PROJECT TITLE HAVILAND FIELDS

ISSUE #	DATE	DESCRIPTION
1	2024-02-09	SITE PLAN REVIEW

LANDSCAPE NOTES / GRAPHIC LEGEND

L002

LS1101

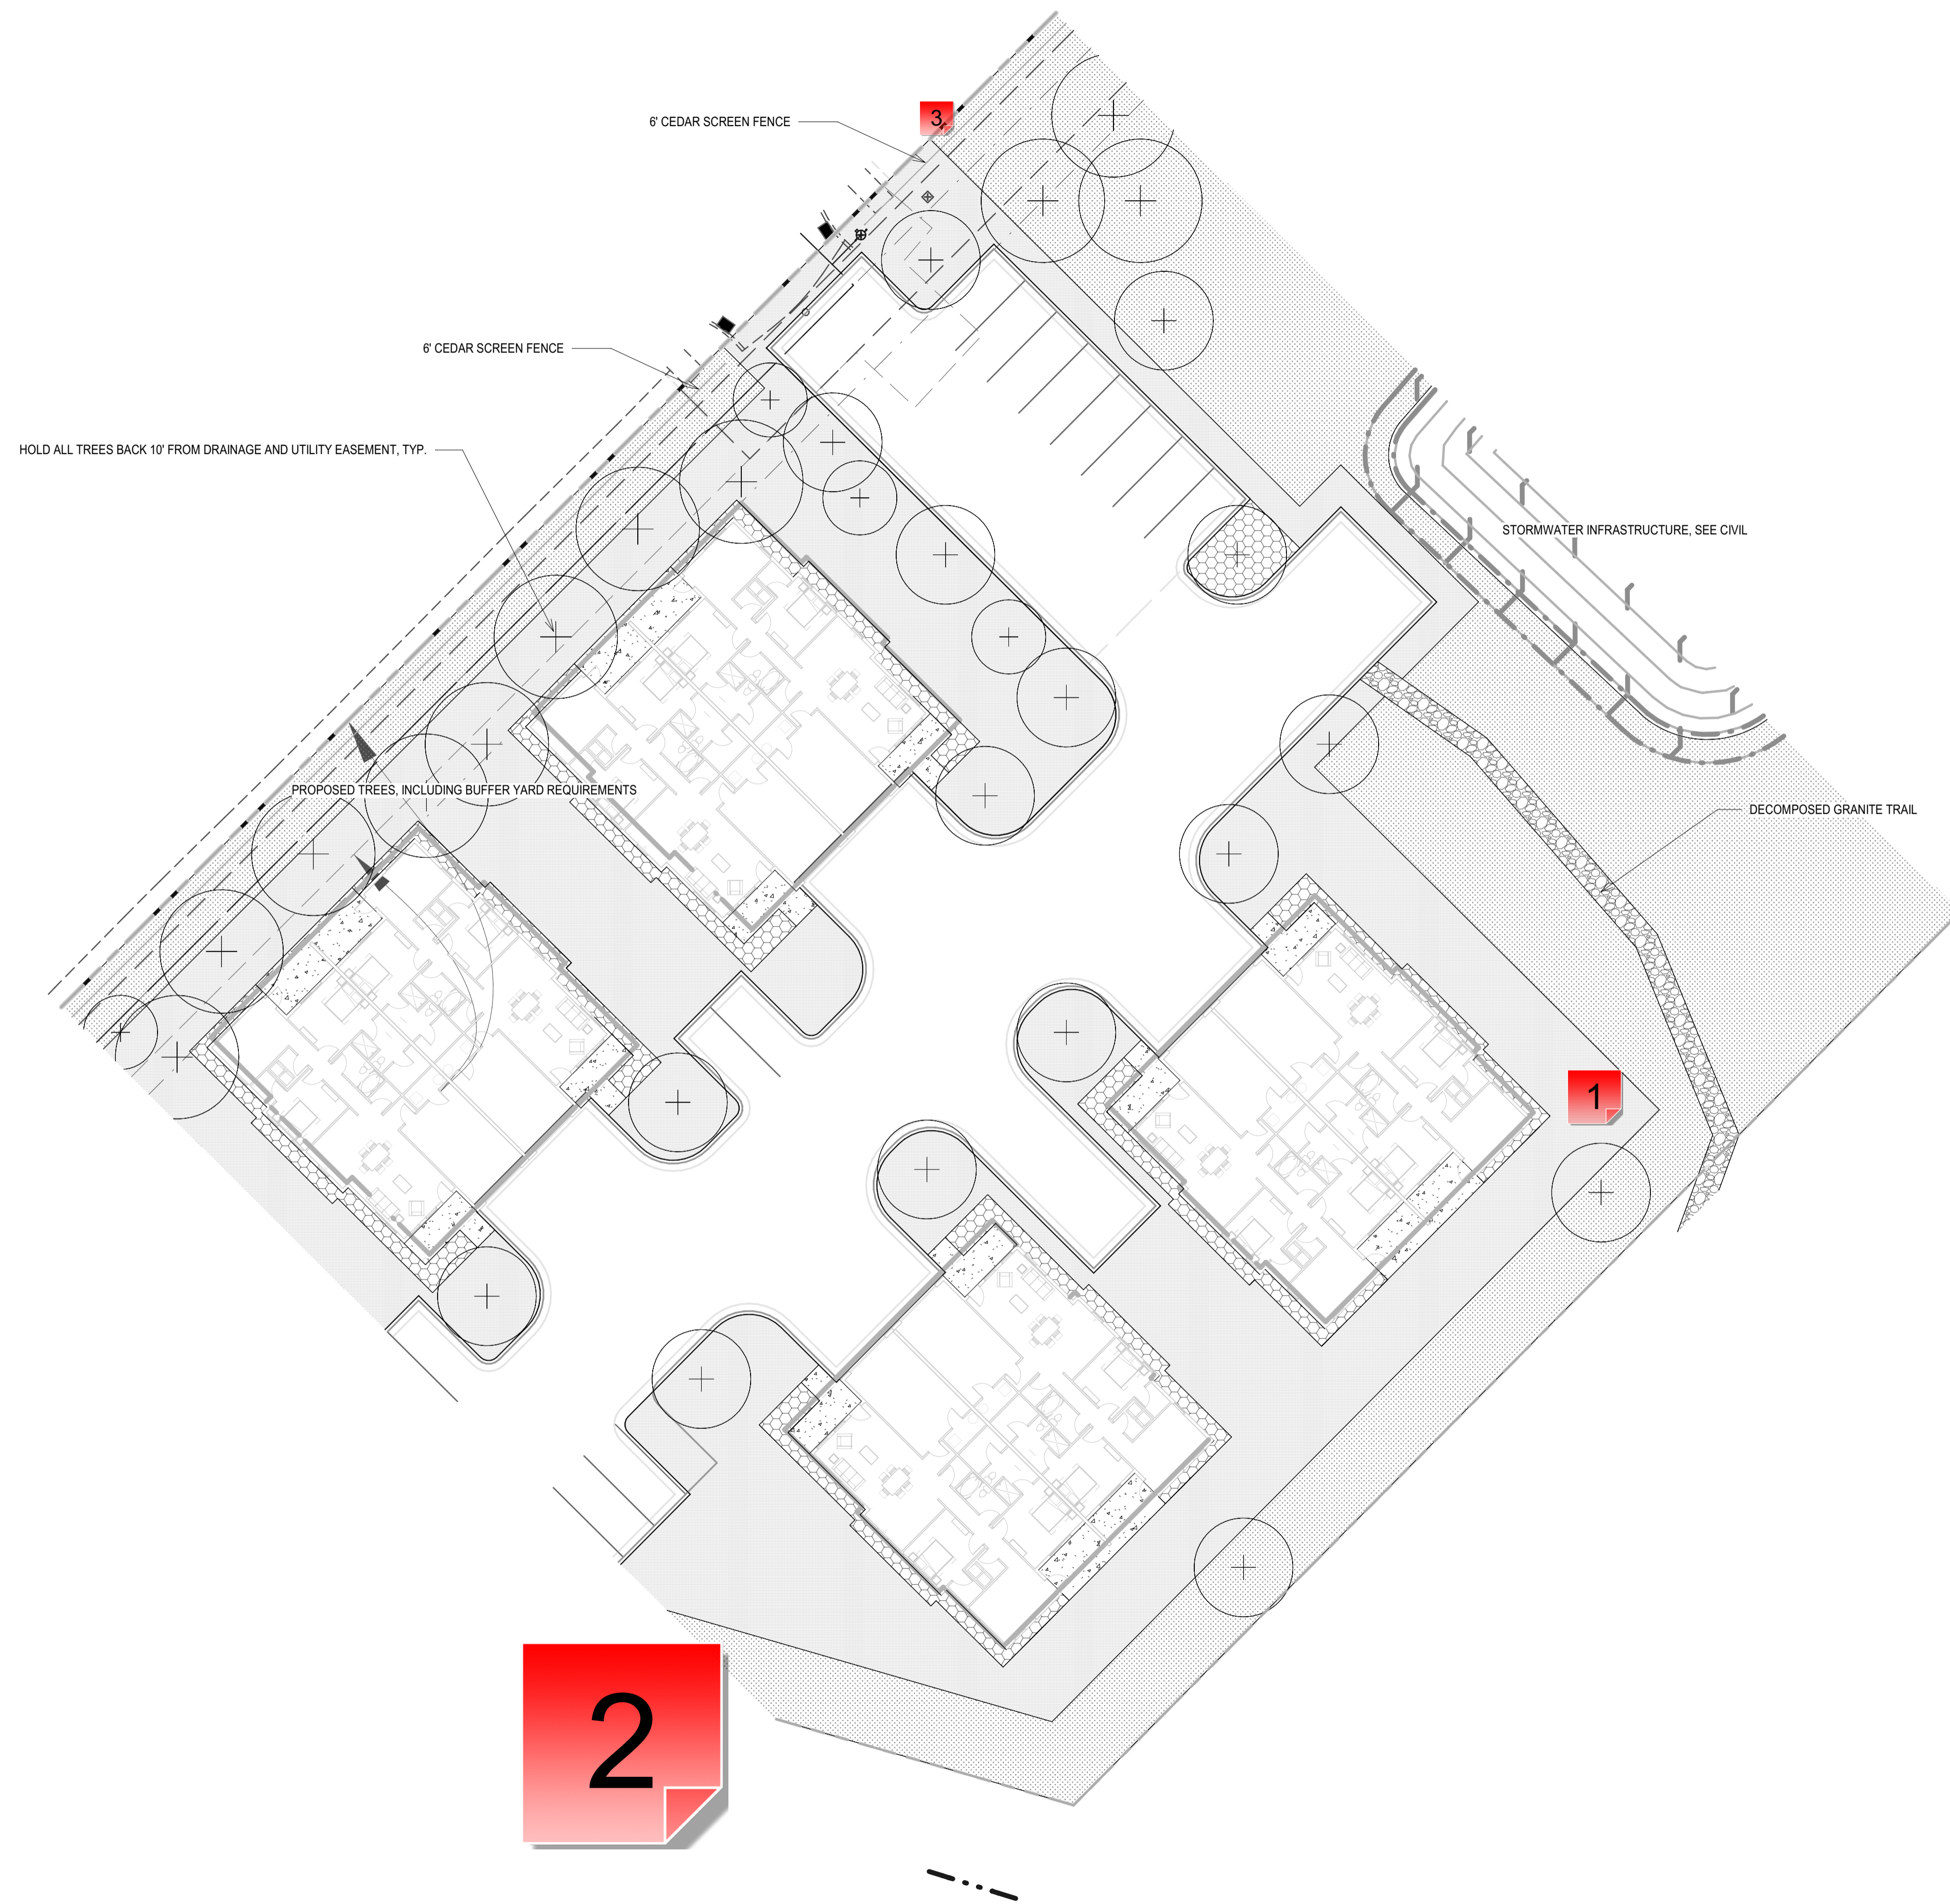
This doesn't appear to be included in the legend, what is this material? Please add symbol to legend.

Please add lables to trees that correlate with the Proposed Plant Schedule here and on all subsequent pages.

Staff would strongly recommend standard turf grass outside the fence to create a more 'maintained' appearance against the existing residential areas.

1
LS1102 TOWNHOMES ZONE C - LANDSCAPE PLAN
1" = 20'-0"

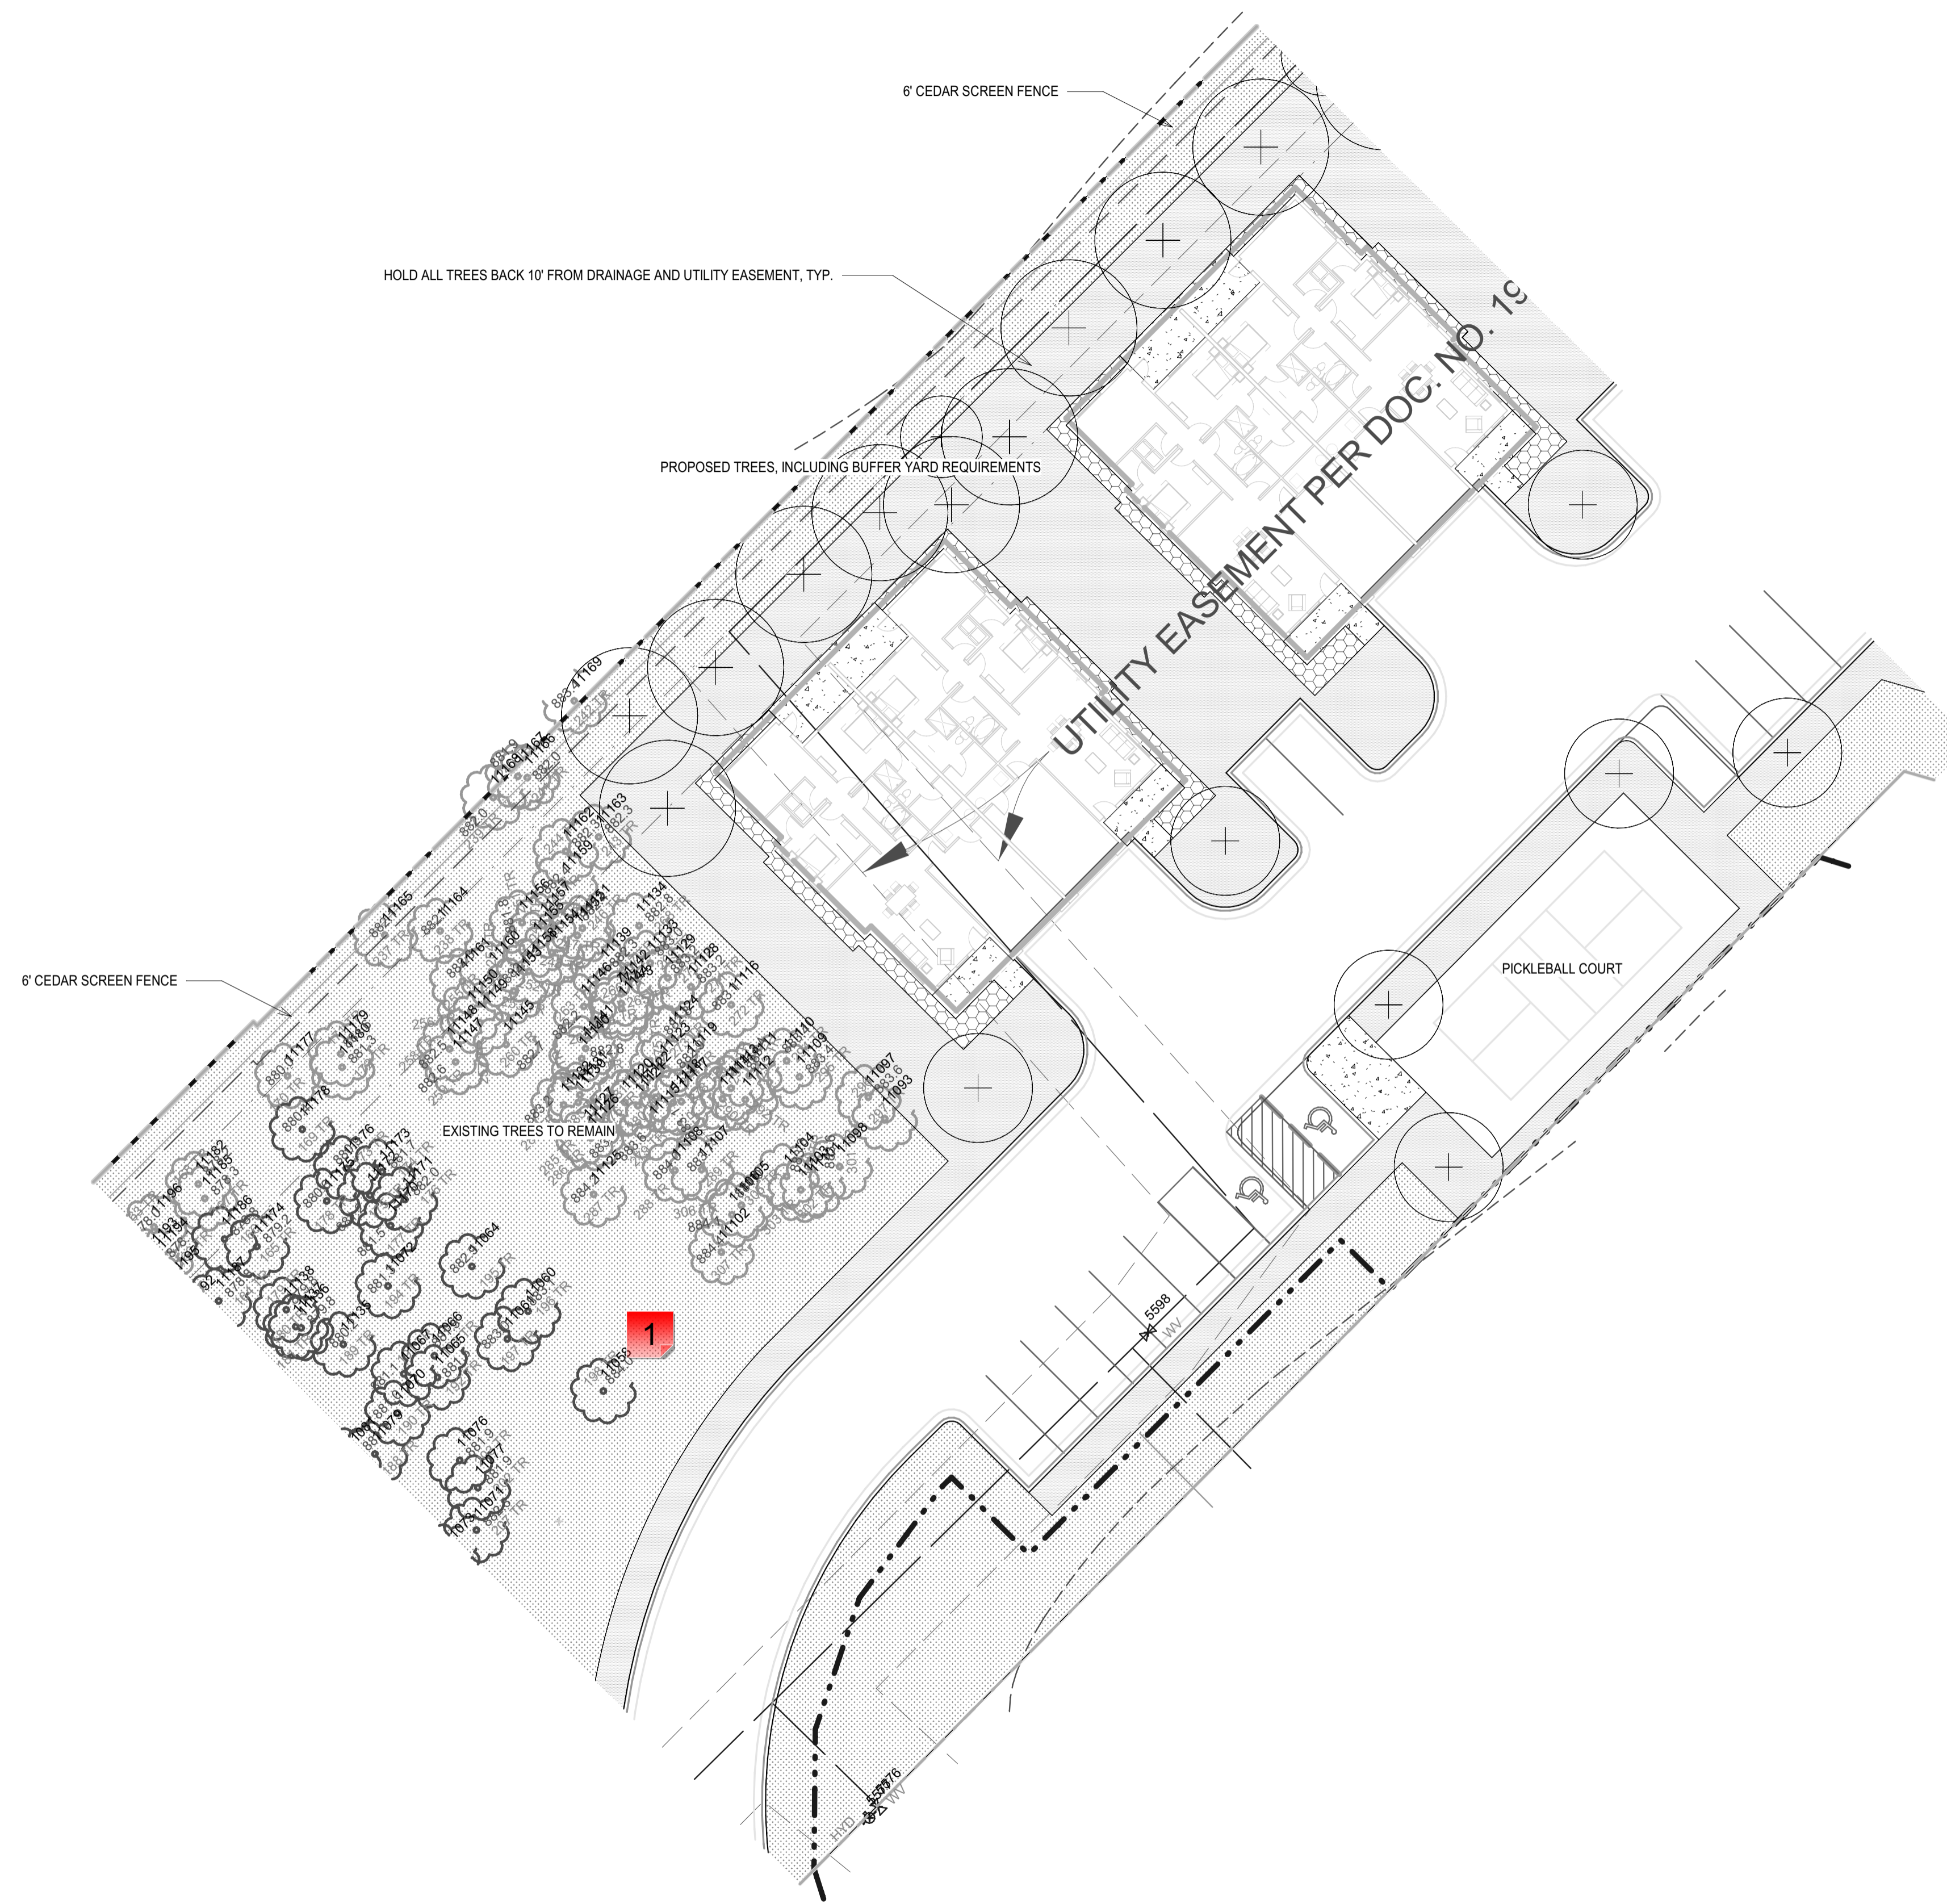
What do the 5-digit numbers represent? For example, tree 198, it appears to be at an elevation of 884.0, but what does the 11058 represent? In many instances, it's making things illegible.
